Drainage Concerns

8459 Shady Grove Rd
North Richland Hills, TX 76182

A resident-focused review of potential stormwater impacts from added roof area, hard surface, and changed grading.

Case ZC26-0169: Special Use Permit for a secondary living unit / detached garage accessory structure.

Approximate roof runoff volume

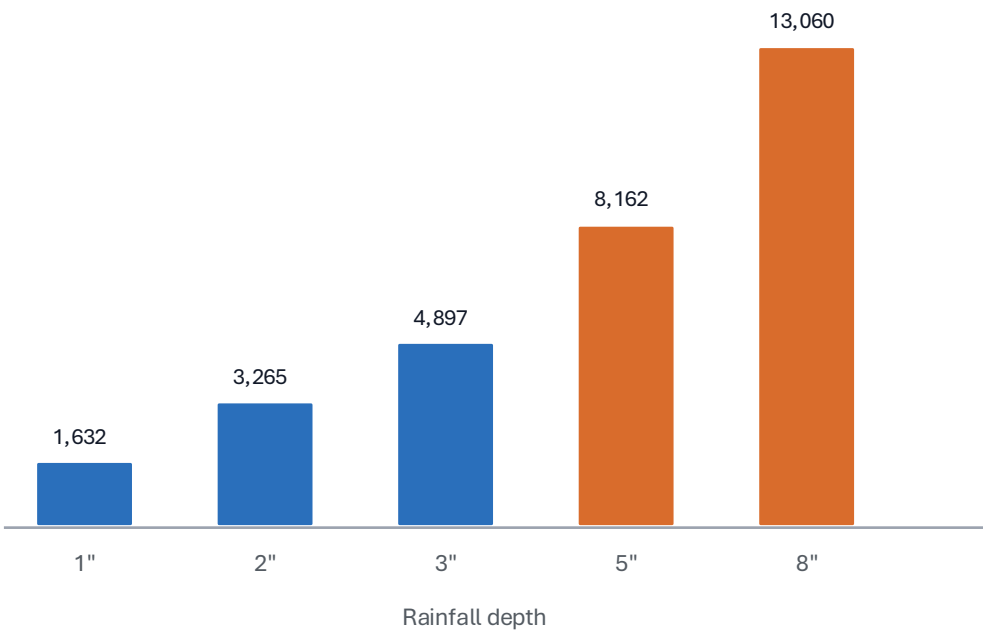
≈1,630 gal

per 1 inch of rainfall on the measured 2,620 SF roof area

Roof-only calculation. Total impervious impact increases if driveway, patios, walks, and compacted fill are included.

01 SITE PLAN
SCALE: 1/8" = 1'-0"

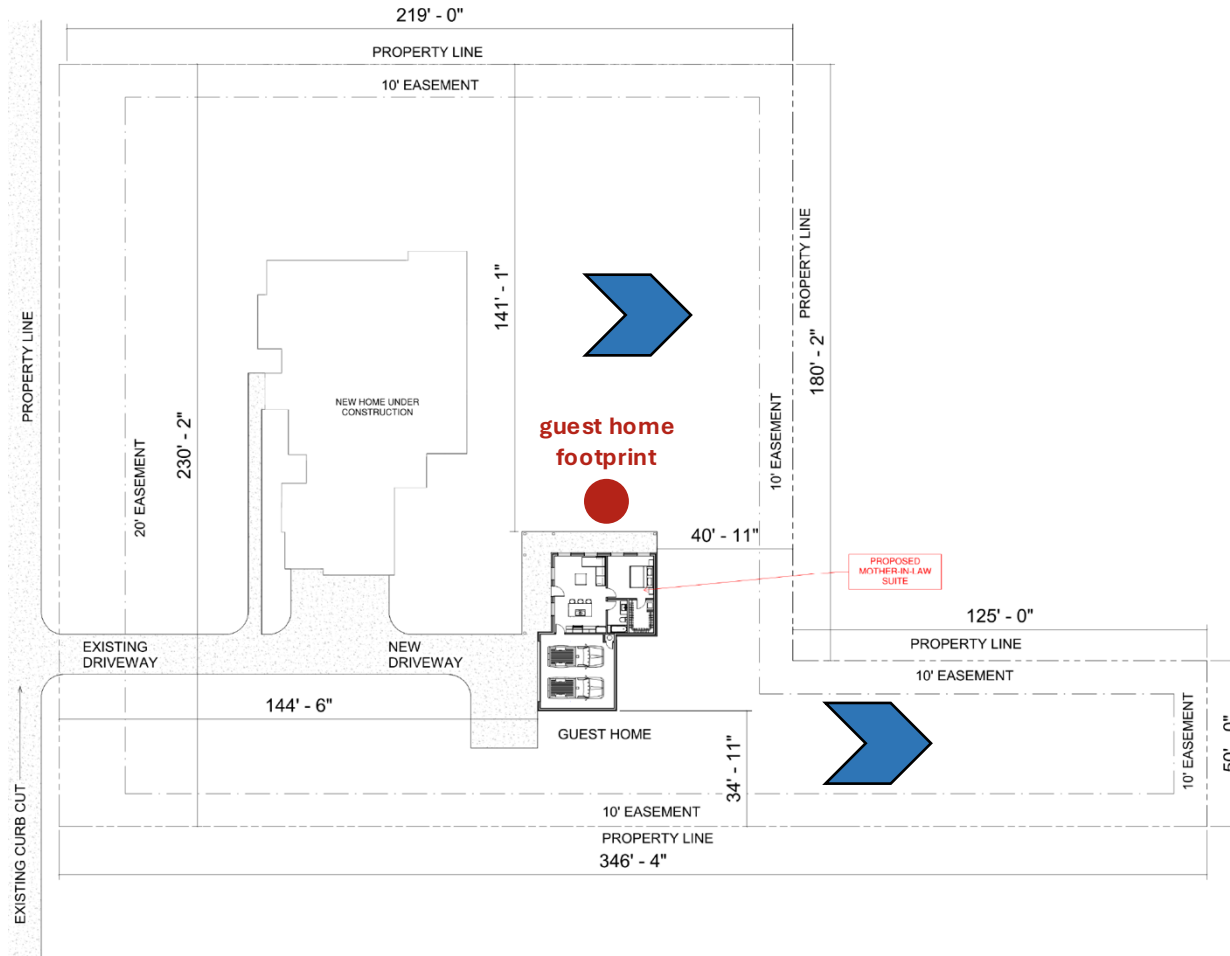
The accessory structure is paired with a new driveway and grading changes that need to be reviewed together.

- Pre-construction vs proposed topography and grade arrows.
- Downspout discharge locations and whether flow is concentrated.
- Driveway cross-slope and whether it directs runoff to the street or side yards.
- Any fill placed near property lines, easements, or neighboring low points.
- Whether runoff crosses more than two residential lots before reaching a street or drainage easement.[4]

The architectural site plan does not establish final grades or runoff routing. Residents request a separate grading/drainage review showing elevations, flow arrows, downspout discharge points, and runoff controls.[3][4][6]

Runoff 1 — broad disturbed surface and apparent channel through the yard.

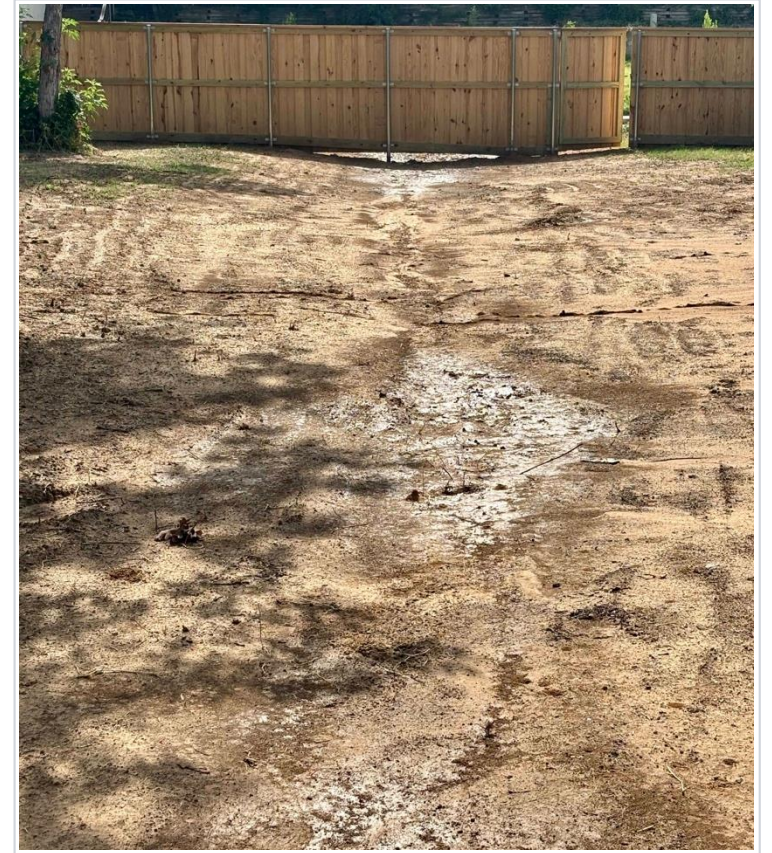
Resident photographs taken after wet conditions show visible flow concentration and erosion pathways.

These images support a request to document pre- and post-construction flow direction, discharge locations, and erosion controls. The exact watershed and discharge route require professional survey/engineering confirmation.

Potential failure mode: concentrated flow to adjacent lots

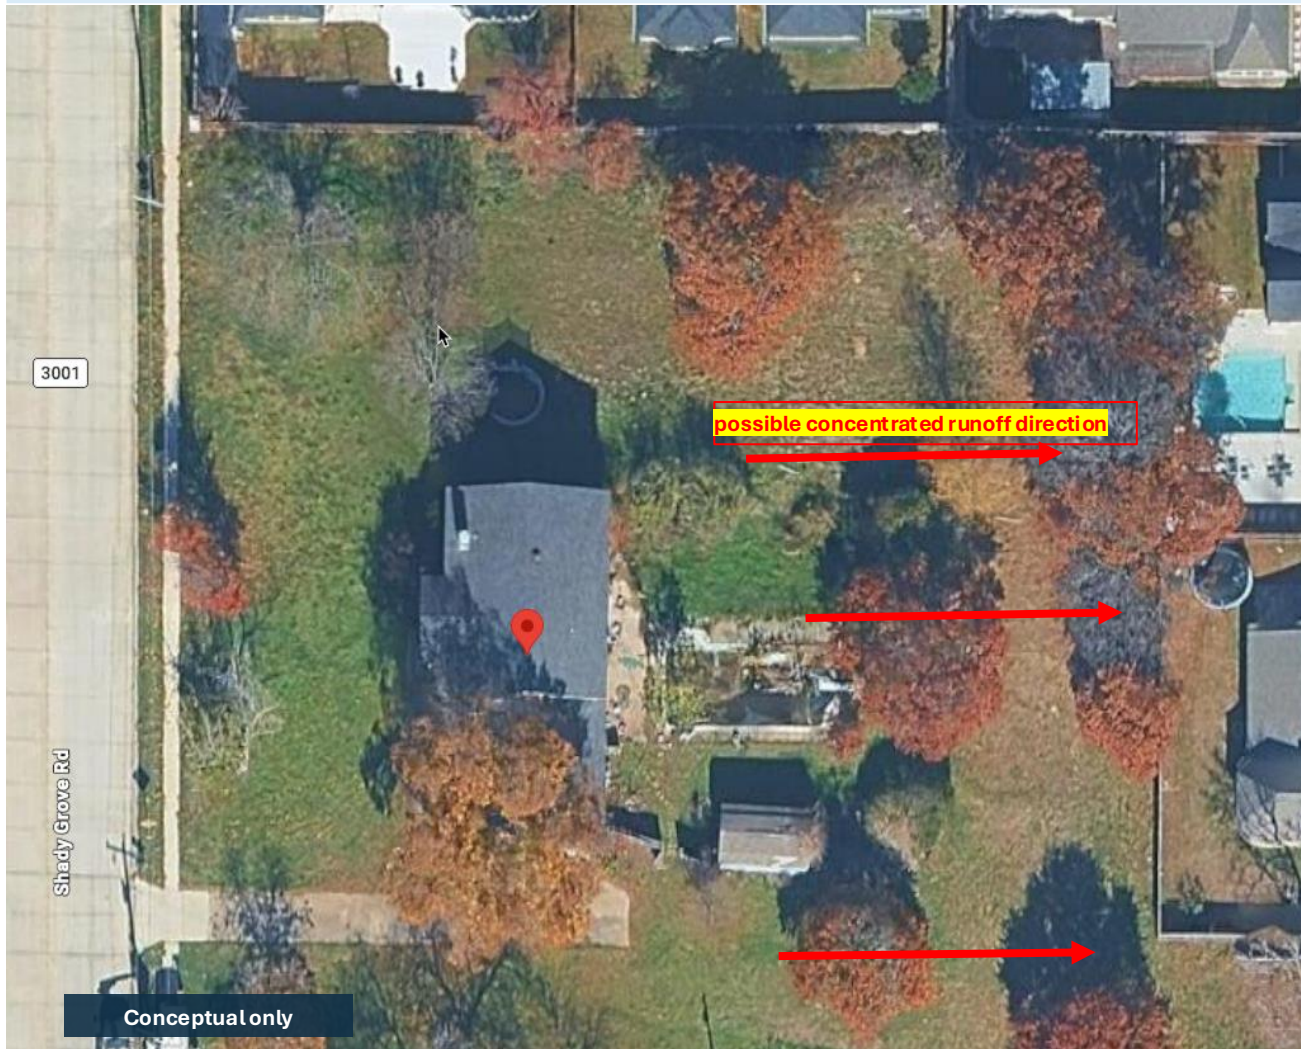
The risk is magnified if regrading and roof leaders convert broad sheet flow into focused runoff.

- Roof leaders discharge toward side or rear yards instead of an approved drainage path.
- Fill creates a berm that blocks historical flow from neighboring properties.
- Driveway pavement becomes a channel that bypasses soil absorption.
- Erosion/sediment reaches neighboring yards during construction before vegetation is restored.
